## **Board Meeting Agenda**

<b>IN THE MATTER OF APPROVING          MODIFICATIONS TO REGIONAL SURFACE          WATER SUPPLY PROJECT AND RELATED          CEQA ADDENDUM TO FINAL EIR</b>	} } } }	<b>RESOLUTION NO. 2021-____</b>
--	------------------	---------------------------------

2.1	Purpose and Objective.....	2-1
2.2	Description of Project Modifications.....	2-1
2.3	Finding.....	2-4
<b>Chapter 3</b>	<b>Evaluation of Environmental Effects</b> .....	<b>3-1</b>

**Figure 2**  
 Revised Site Plan  
 Surface Water  
 Supply Project

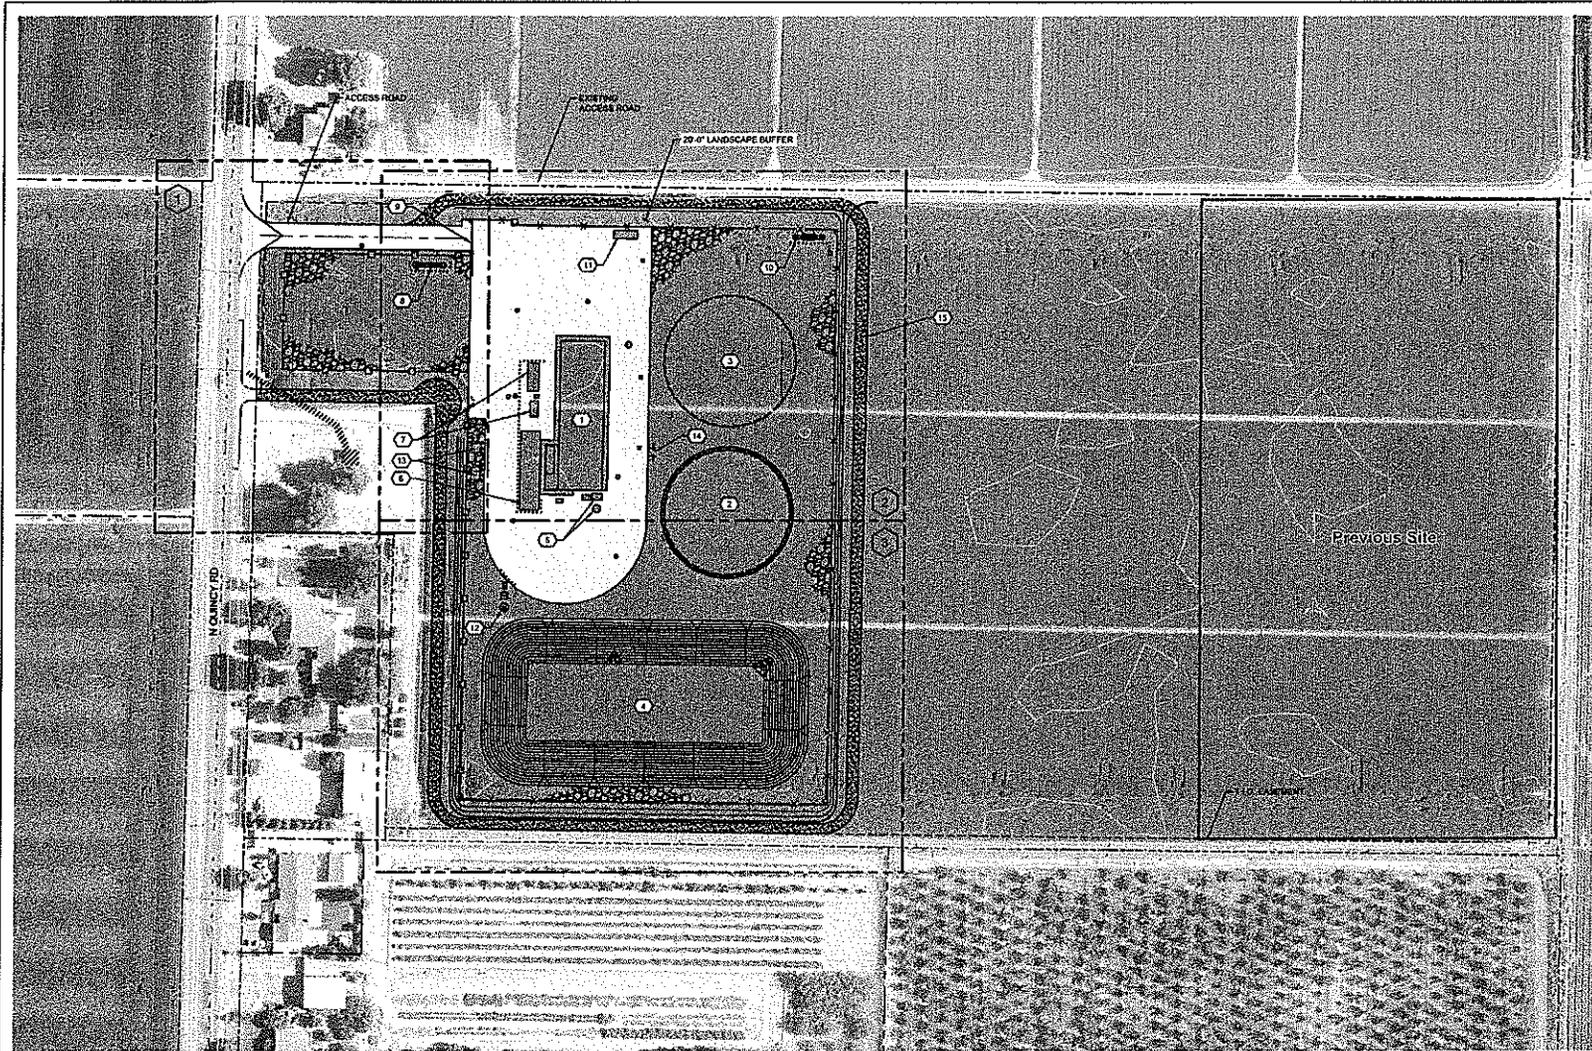
***Westward Shift of Turlock Terminal Tank Site:*** The City of Turlock has negotiated with the owner of the tank parcel to purchase the entire property, rather than only the eastern third of the parcel. This modification allows the City to shift the terminal facilities closer to North Quincy Avenue (**Figure 2**), reducing pipeline construction costs and avoiding additional costs related to the facilities' proximity to TID's canal on the east. Redesign of the site plan includes a setback and landscape buffer from the adjacent residential property to the west, as well as adjustments to the location of the emergency generator and addition of an enclosure for the generator. Additional biological and cultural resource surveys have been conducted to address the entire property.

***Increase in Turlock Tank Height:*** Upon detailed design of the tank facilities, the City's engineers have determined that the tank would be up to 40 feet tall, rather than 30 feet as described in the EIR.

***Radio Towers at Ceres and Turlock Tank Sites:*** Radio towers at each tank site will allow the terminal facilities to communicate with operators at the water treatment plant. The Turlock tower will be 100 feet tall, and the Ceres tower will be 38 feet tall.

The Turlock tank site has been redesigned from the site plan depicted in the EIR, in light of its greater proximity to residential uses. An emergency generator (size KD1250-1750) would be installed at the site within a noise-reducing enclosure (SL2 Sound Enclosure with Internal Silencer and State Code Subbase Fuel Tank); this information is provided in **Appendix D**. The emergency generator at the terminal tank site would be tested for approximately 1-hour periods and for no more than 50 hours per year, in accordance with operating permit conditions.
